ORDINARY COUNCIL

Item	Subject	Page
12.11	SECTION 4.55 MODIFICATION DA2010 - 577.4 - MODIFICATION TO SUBDIVISION LOT LAYOUT INCLUDING ADDITION OF ONE (1) TORRENS TITLE LOT - LOT 2 DP 1231106, NO. 72 LORNE ROAD, KENDALL	
	Attachment 1: DA2010 - 577.4 Plans	4
	Attachment 2: DA2010 - 577.4 Stormwater Report	6
	Attachment 3: DA2010- 577.4 Stormwater Plan.....	12
	Attachment 4: DA2010 - 577.4 Buffers Sewage Management Onsite	13
	Attachment 5: DA2010 - 577.4 Onsite Report	16
	Attachment 6: DA2010 - 577.4 Recommended Amended DA Conditions	20
	Attachment 7: DA2010 - 577.4 NSW Rural Fire Service Recommendations	34
	Attachment 8: DA2010 - 577.4 Submission - Guy.....	36

1st May 2018Our Ref: 7218
Your Ref: DA 2010/577General Manager
Port Macquarie Hastings Council
PO Box 84
PORT MACQUARIE NSW 244Attn: Mr Clinton Tink**WINNER**
2009**Directors****MICHAEL S MOWLE**
B E Civ (Hons)
Chartered Engineer**GEOFFREY E HILL**
B Surv
Registered Land Surveyor**DANIEL J BAKER**
B Surv
Registered Land Surveyor**DARREN J BOOTH**
B Surv
Registered Land Surveyor**Re: THE MEADOWS (DA2010.577) – PRELIMINARY STORMWATER REPORT**

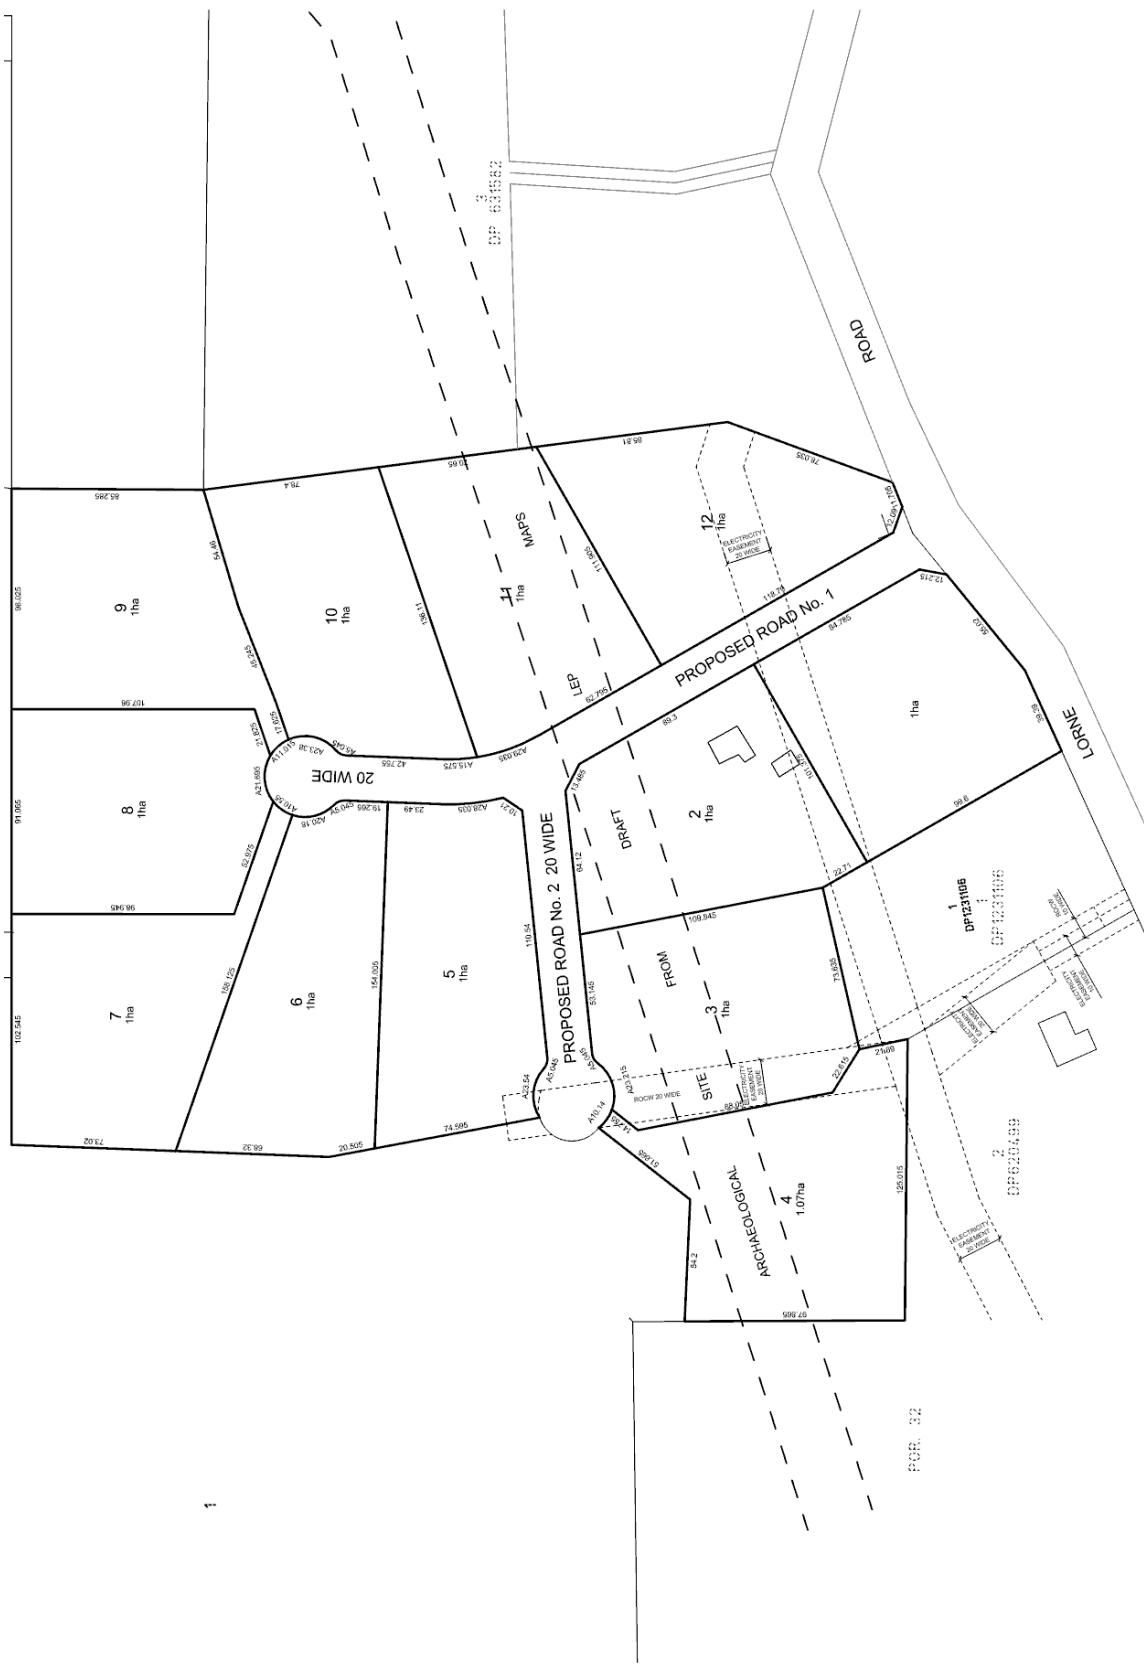
The proposed subdivision layout is shown on the attached plan. Road #1 is centred on the main ridge with a cul-de-sac head serving Lots 7, 8 & 9. Road #2 runs to the West serving Lots 3 & 5 and provides access to the neighbouring property.

The existing gully will be the main drainage path for all stormwater from the developed site. Culverts will be sized and located approximately as shown under Road #2 and the access handle to Lot 7. The road, cul-de-sac head and table drain levels will be designed to direct flows into the gully on the West side of Road #1 and well clear of any building envelope.

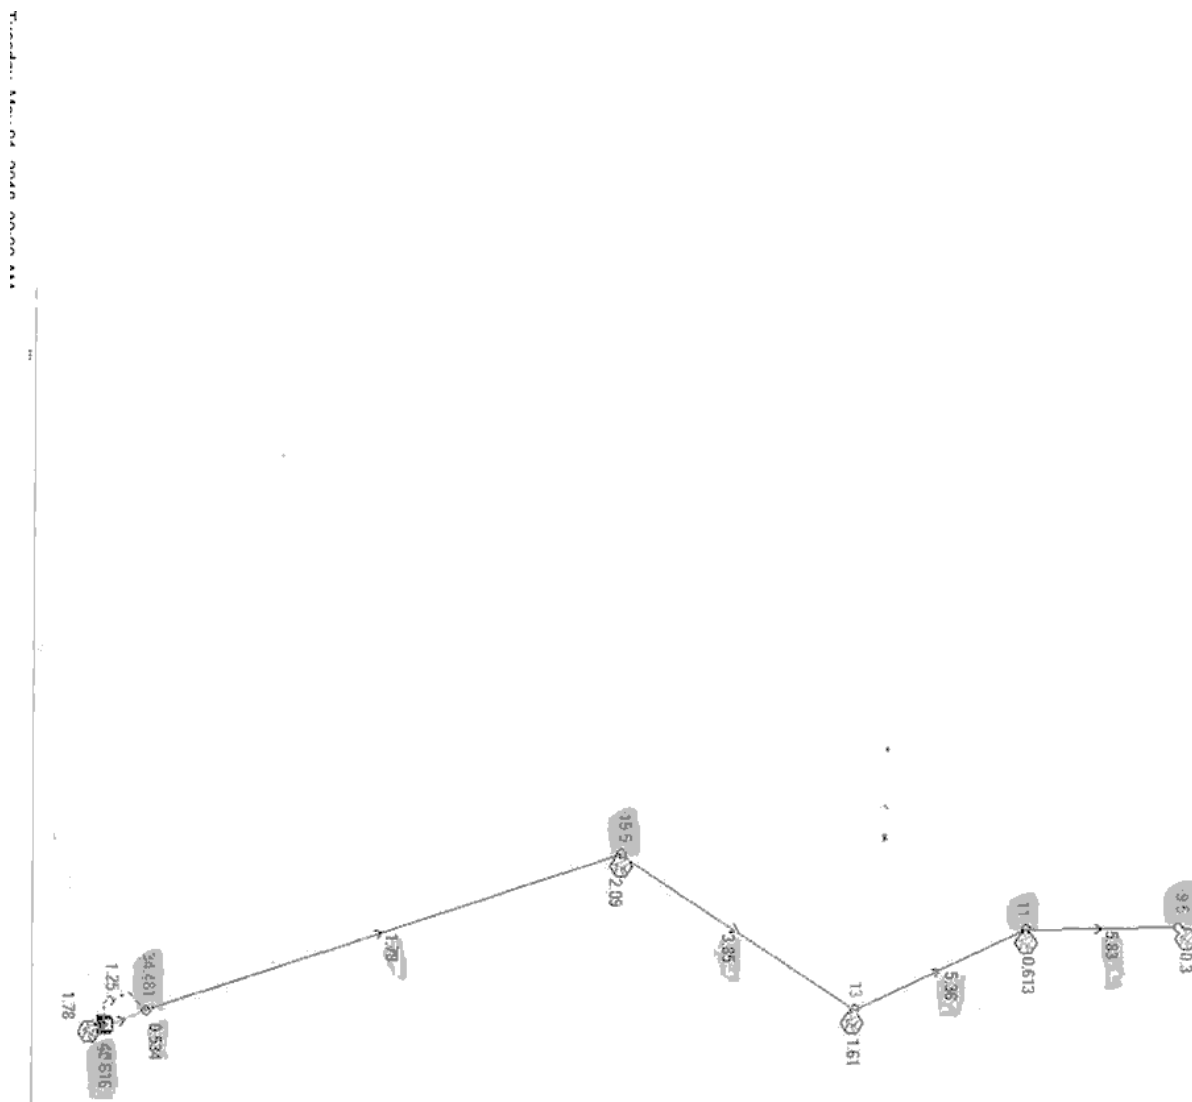
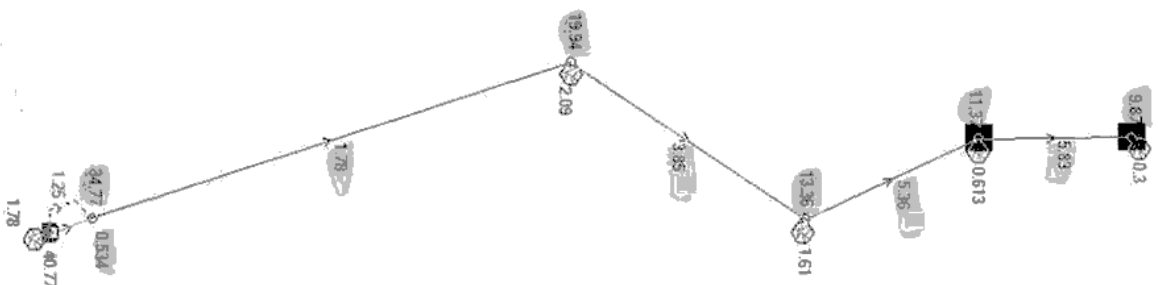
A DRAINS 2016 AR&R analysis demonstrates that 1:100 Pre-Development flows = **5.81 cu.m/s** resulting in a water level of RL11.37AHD adjacent Lot 7 (depth of flow in channel = 370mm).

A Post development analysis demonstrates flows = **5.83 cu.m/s** resulting in a water level of RL11.37 AHD adjacent Lot 7 (depth of flow in channel = 370mm).

1. There is a minimal difference (0.02cum/s) between pre-development & post development flows. Both scenarios result in the same water level & this is due to modelling sensitivity ie. not enough variation in discharge to alter flow depths.
2. The similarity between pre & post development discharges is due to the modelling of major storm events (after initial losses) creates a surface saturation which is effectively an impervious catchment in both scenarios. Hence the impact of houses, sheds, road pavements & hard surfaces etc. becomes negligible in the post-development modelling scenario.

ATTACHMENT 1 – 40M BUFFER ZONE

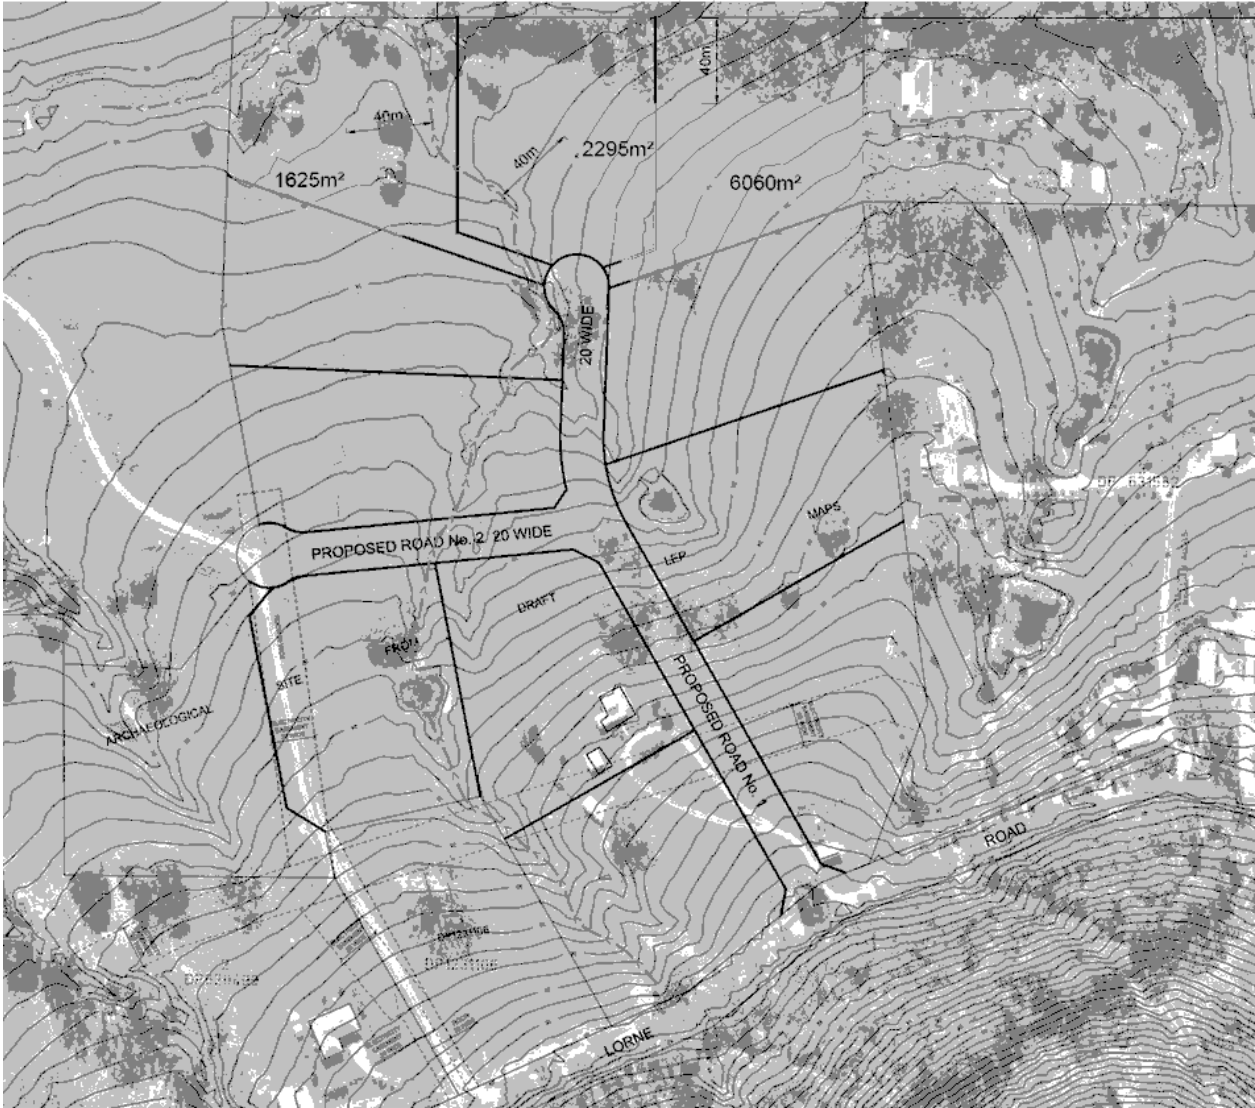
Following your request the issue of the implications of the recommended 40m buffer to the intermittently flowing creeks/gullies which have been identified on and off the subject site in relation to the residential occupation and use of proposed Lots 9, 10 and 11 has been the subject of further review. This has involved the identification of intermittently flowing creeks and the determination of the extent of the recommended 40m buffer zone as applied to the proposed modified lot layout.

Please find attached a plan which identifies the constraints to onsite effluent disposal which are imposed by the recommended 40m wide buffer zone. This approach has taken a conservative approach to the determination of those areas of each of the proposed lots which is constrained by the 40m buffer zone and other property boundary setbacks which maybe applicable to the installation of onsite sewage management systems. In this regard the following areas of each of the proposed lots remain unconstrained by the 40m buffer zone;

PROPOSED LOT	AREA OF LAND OUTSIDE OF 40m BUFFER ZONE
Lot 9	Approximately 6060m ²
Lot 10	Approximately 2295m ²
Lot 11	Approximately 1625m ²
